RE: Responses to the Environmental Report Request for Additional Information for the Nichols Ranch
ISR Project License Application (TAC J00553, Docket No 040-09067)

**Request for Additional Information
Regarding the Uranerz Energy Corporation's
Nichols Ranch ISR Project License Application
Environmental Report – Uranerz Energy Corporation Responses**

FIGURE 3-23

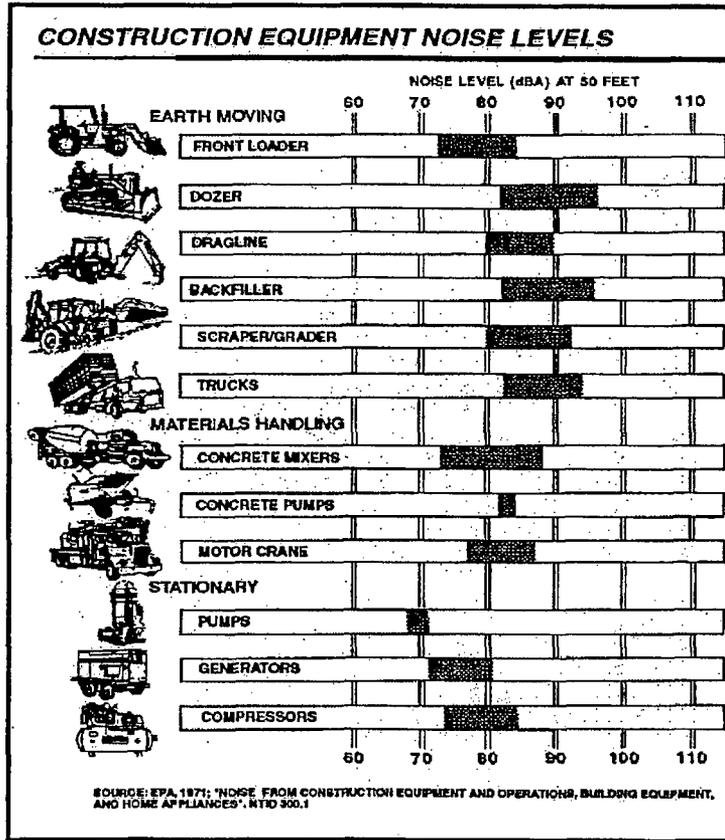
NOI-2 ER Section 4.9.1. The ER states that "noise is created by the construction/drilling activities in the wellfield, from truck traffic for the operation, and from the operation of the processing plants..." However, no projections of noise levels were provided for the proposed project.

- a) Provide projections of typical equipment and their reference sound levels that would be associated with activities during each phase of the proposed project.

URZ Response:

Typical equipment that will be used for the Nichols Ranch ISR Project and their noise levels are below. Section 4.9.1 has been revised to include this information.

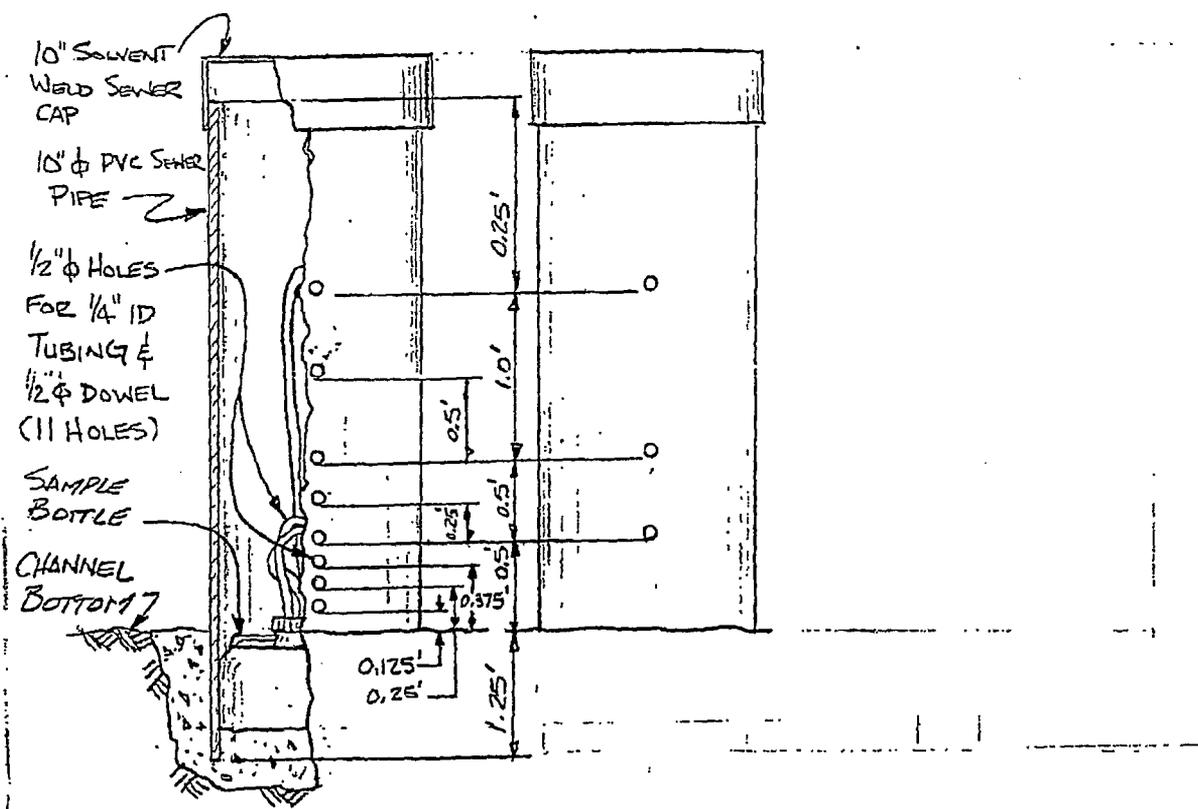
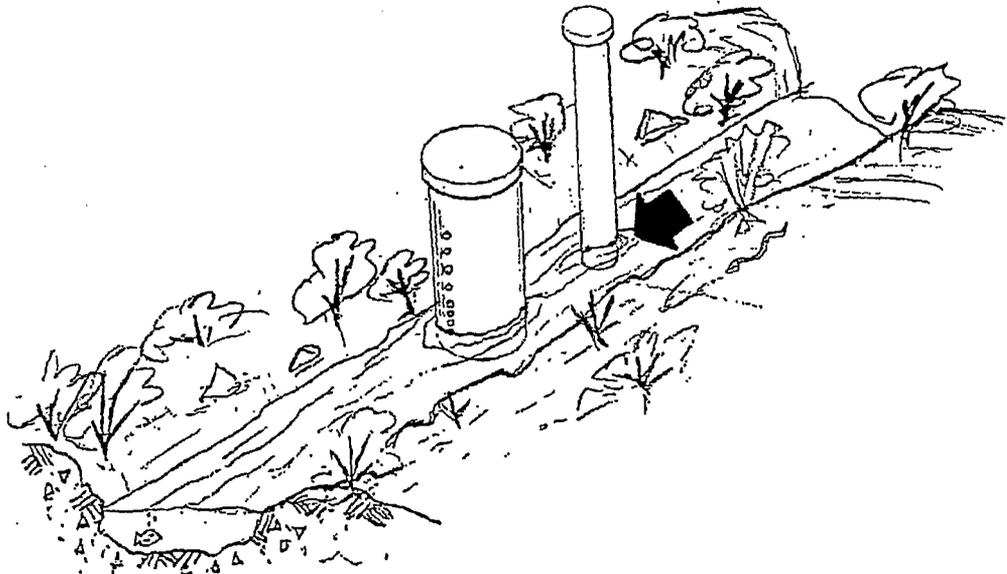
maintained, and improved as necessary." Additional information is necessary to adequately assess the proposed mitigation strategies. Discuss how the onsite and local roads will be maintained throughout the life of the project.

URZ Response:

On-site (in the license area) roads and local (ranch) roads will be maintained to ensure the safe travel of users. This includes the removal of snow by motor grader, plow, or front end loader when snow is present, repairing any road when ruts greater than 3 inches are present, and keeping the road in overall good condition. Since these roads are improved dirt crowned and ditch roads, they will frequently be sprayed with water for dust suppression. The maintenance of roads in the license area will be handled by Uranerz. Ranch or local roads will be maintained by Uranerz. Any maintenance conducted on local roads will be conducted in consultation with the landowner to ensure that the landowners desired road construction methods are adhered to. These methods will be employed for the entire life of the project.
